***MODIFICATION REQUEST:
Sydney Metro City and Southwest -
Chatswood to Sydenham***

***Modification to Victoria Cross
Station and Artarmon Substation
SSI 7400 (MOD 1)***

Secretary's Environmental Assessment
Report
Section 115ZI of the
Environmental Planning and Assessment
Act 1979

Figure 1: Proposed relocation of Victoria Cross northern services building, additional access and construction site (Source: Victoria Cross Station and Artarmon Substation Modification Report, TfNSW 2017)

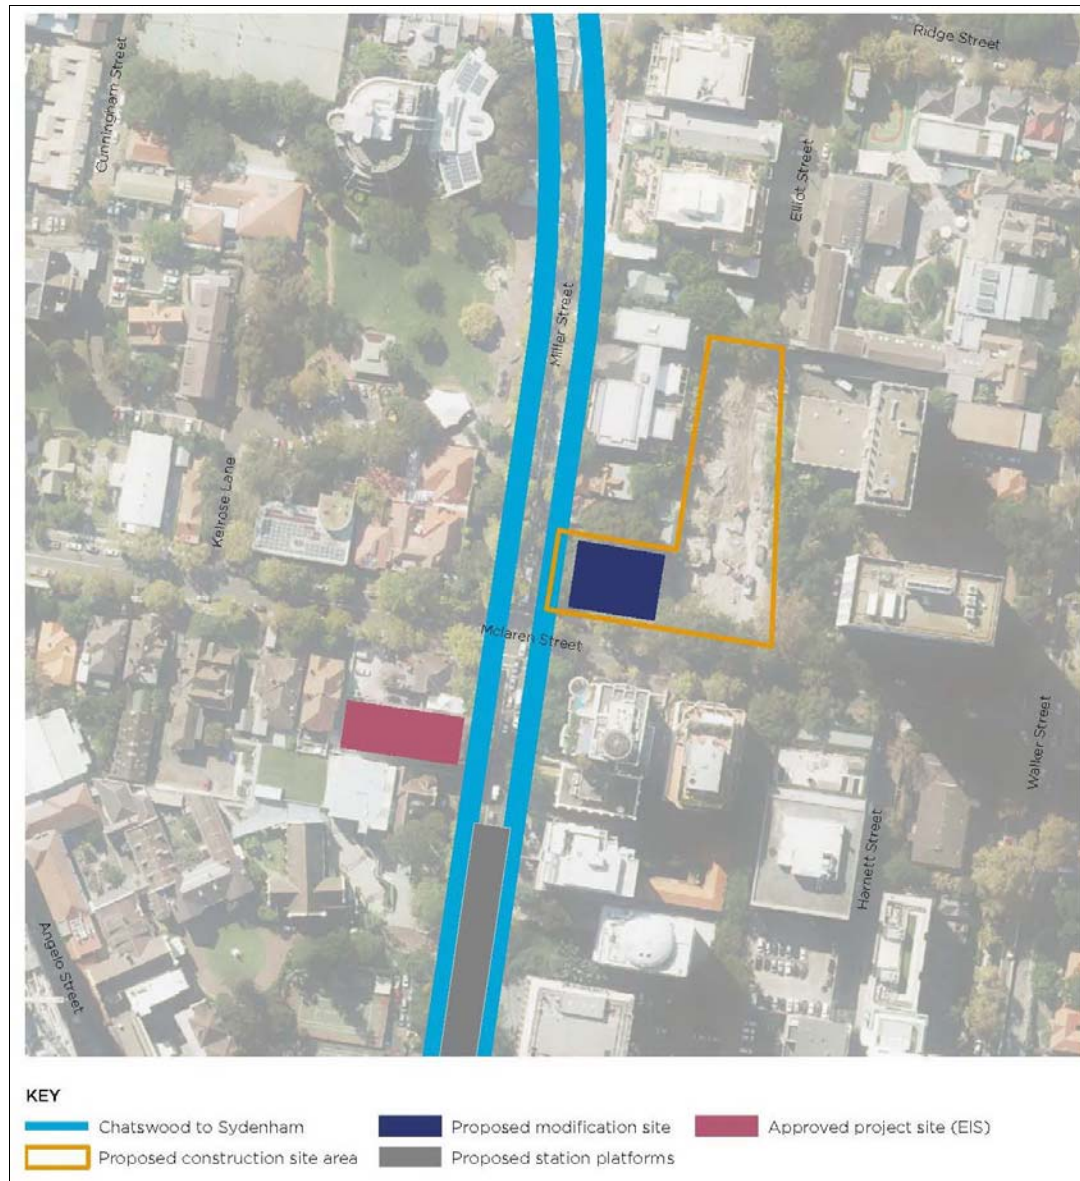
TfNSW proposes to relocate the Victoria Cross northern services building from 194-196A Miller Street to a new location at 50 McLaren Street, North Sydney and provide a new lift only station access at this location (see **Figure 1**). The northern entrance and services building would be at the north-east corner of McLaren and Miller Streets and cover an area of 4,180 square metres.

Figure 2 Northern station entrance and services building proposed setbacks (Source: Victoria Cross Station and Artarmon Substation Modification Submission Report, TfNSW 2017)

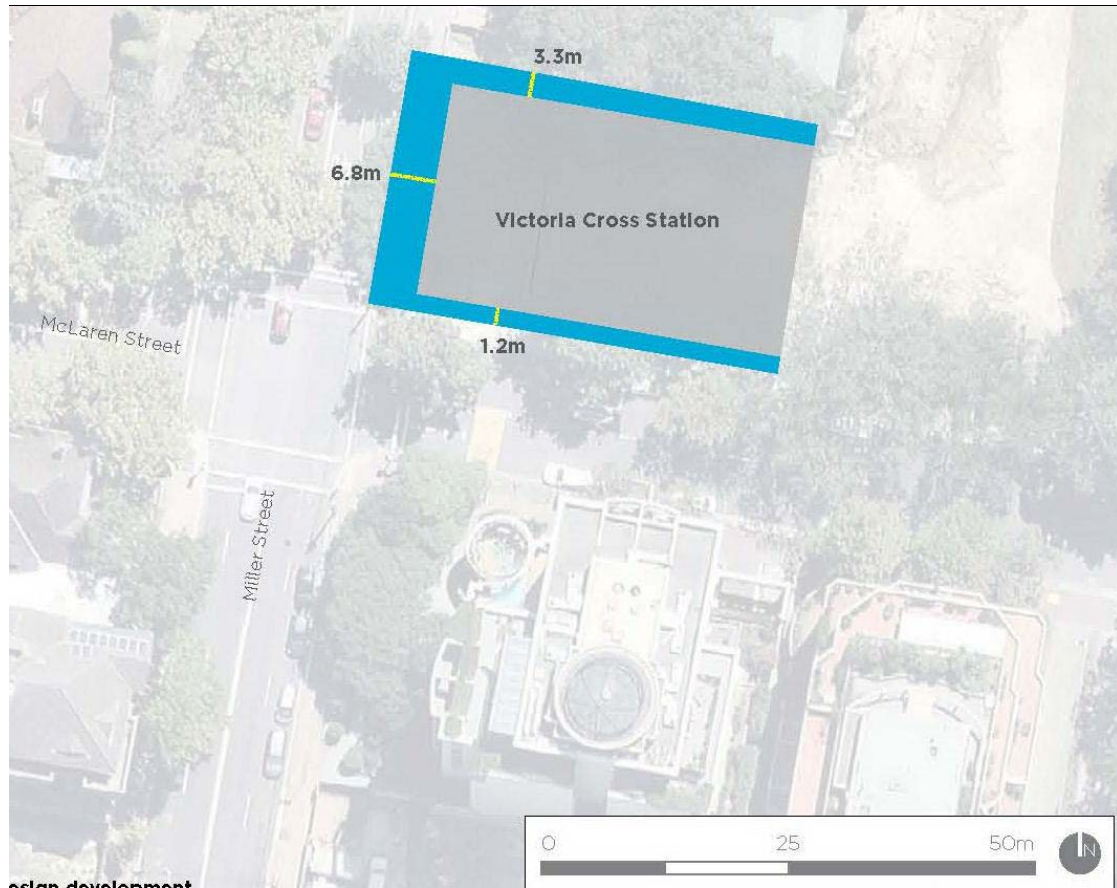
The revised boundary setbacks from the property boundary on Miller Street (from 12 metres to approximately 6.8 metres) and McLaren Street (from approximately 4.5 metres to 1.2 metres) would enable the services building and station entry height to be reduced by approximately five metres. North Sydney Council initially indicated concern with the change in setback, particularly from Miller Street, however following a meeting with TfNSW to clarify this proposed change, council officers advised the Department that the setbacks, being from the property boundary and not the kerb, were acceptable and that it had no further concerns with the proposed modification.

Figure 5 Proposed haulage route for Victoria Cross northern services building (Source: Victoria Cross Station and Artarmon Substation Modification Report, TfNSW 2017)

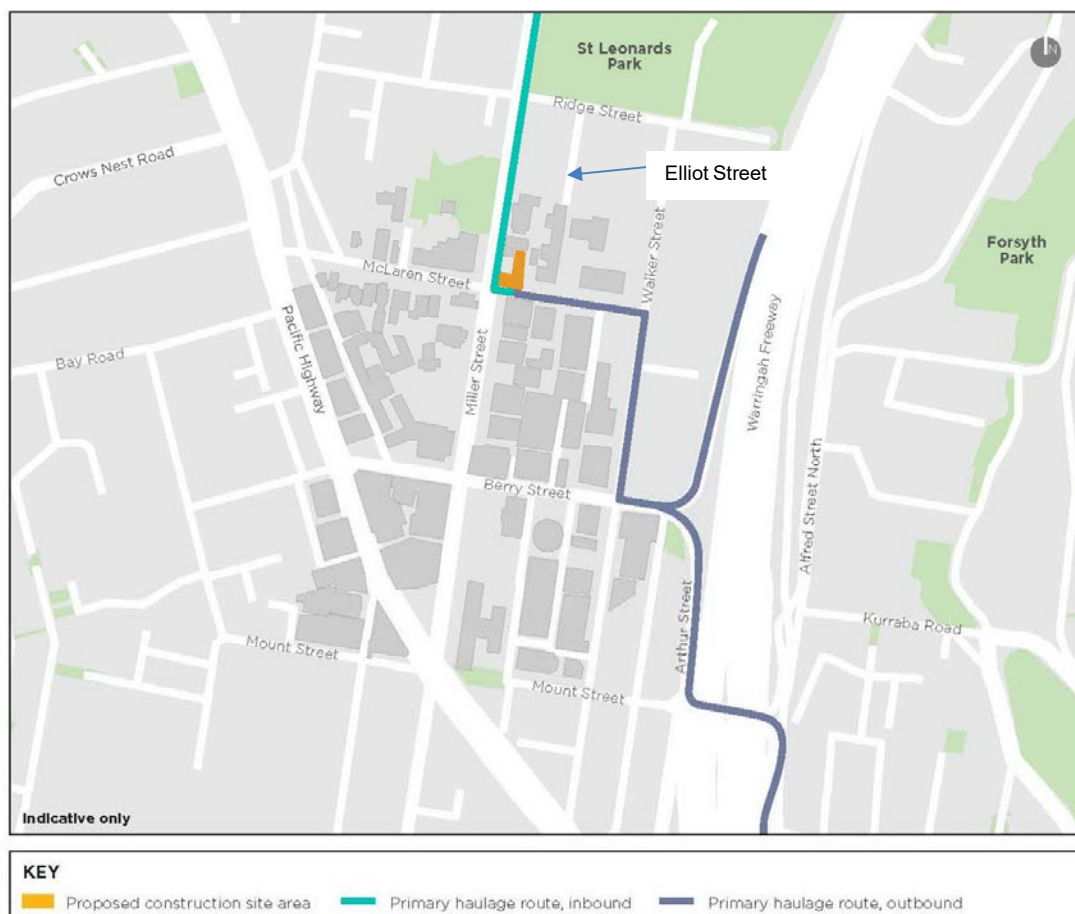
Construction traffic movements would be limited to primarily left-in and left-out of 52 McLaren Street (**Figure 5**) and scheduled to avoid school drop off and pick up times. The proposed haulage route is similar to that proposed in the EIS, with the exception of traffic using McLaren Street and Walker Street. Secondary and/or alternate access may also be established from Elliot Street (zoned mixed use but partly adjoins a low density residential area), McLaren Street and Miller Street.

In its submission, Wenona School requested that Elliot Street access be restricted due to potential conflicts with the school and users of Rydges Hotel. Elliot Street is a narrow, no through road, which passes residences, a hotel and the school. TfNSW confirmed its intention to only use Elliot Street as a secondary access where access is required for emergency situations. The Department, has therefore, recommended a condition restricting use of Elliot Street to emergency situations. The approach to managing pedestrian access and safety must be addressed in the Construction Traffic Management Framework and detailed in a Construction Traffic Management Plan for the site. The Department considers that the conditions in the Minister's approval will appropriately address this issue.

The Department considers that existing conditions are sufficient to manage construction and operational access, traffic and transport related impacts with the addition of a condition restricting use of Elliot Street. The existing conditions include requirements for the:

Figure 6 Victoria Cross Noise Catchment Areas (labelled with letters) (Source: Victoria Cross Station and Artarmon Substation Modification Report, TfNSW 2017)

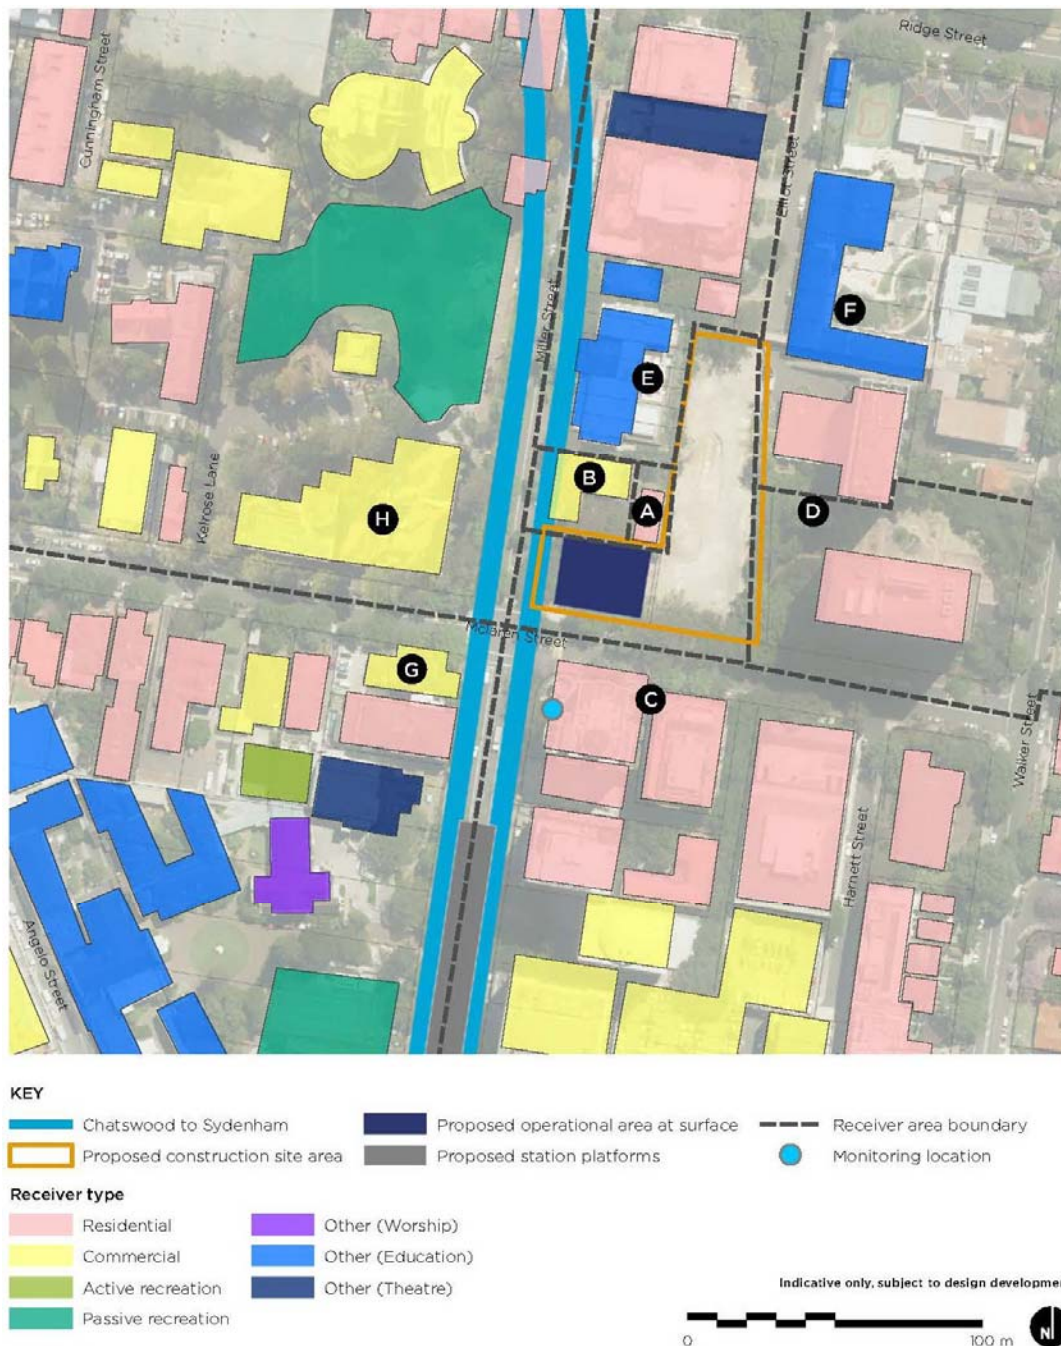
- 30 dBA above the NML during the day and up to 2 dBA during the night for a residential receiver (243 Miller Street) located five metres from the works site (noise catchment A);
- 22 dBA above the NML for the commercial receiver located seven metres from the excavation (noise catchment B);
- 15 dBA above the NML for the residential receiver located 20 metres away from the excavation (noise catchment C); and
- 5 dBA above the NML at Wenona School, located 35 metres away (noise catchment E).

Construction traffic noise is expected to exceed the relevant criterion by 2.5 dB on McLaren and Miller streets at commercial and residential receivers. The sleep disturbance screening criterion and external sleep disturbance Noise Management Level are also likely to be exceeded (by up to 13 dB and 14 dB respectively) in these locations.

The Department is satisfied that the existing conditions of approval with the Proponent's revised commitments including investigating opportunities to minimise heavy vehicle use at night are appropriate to manage the construction and operational noise and vibration impacts.

Figure 8 Morton Bay Fig (*Ficus macrophylla*) on McLaren Street

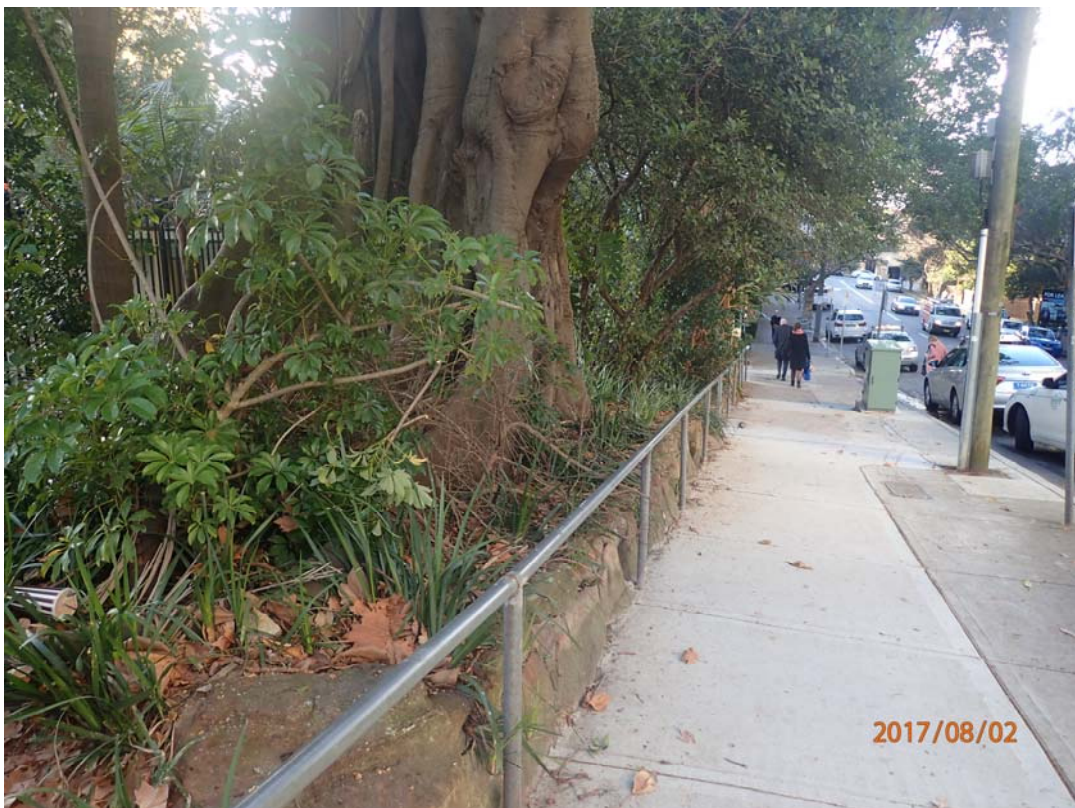
Construction is unlikely to damage the structural root zone of the Morton Bay Fig on McLaren Street that would require its removal. It may be avoided if the roots have been previously impacted by construction adjacent to it, however some pruning may be required. TfNSW has committed to locating temporary facilities to avoid further encroachment of the tree protection zone and to confirm the location of the tree roots by a qualified arborist during initial excavation works.
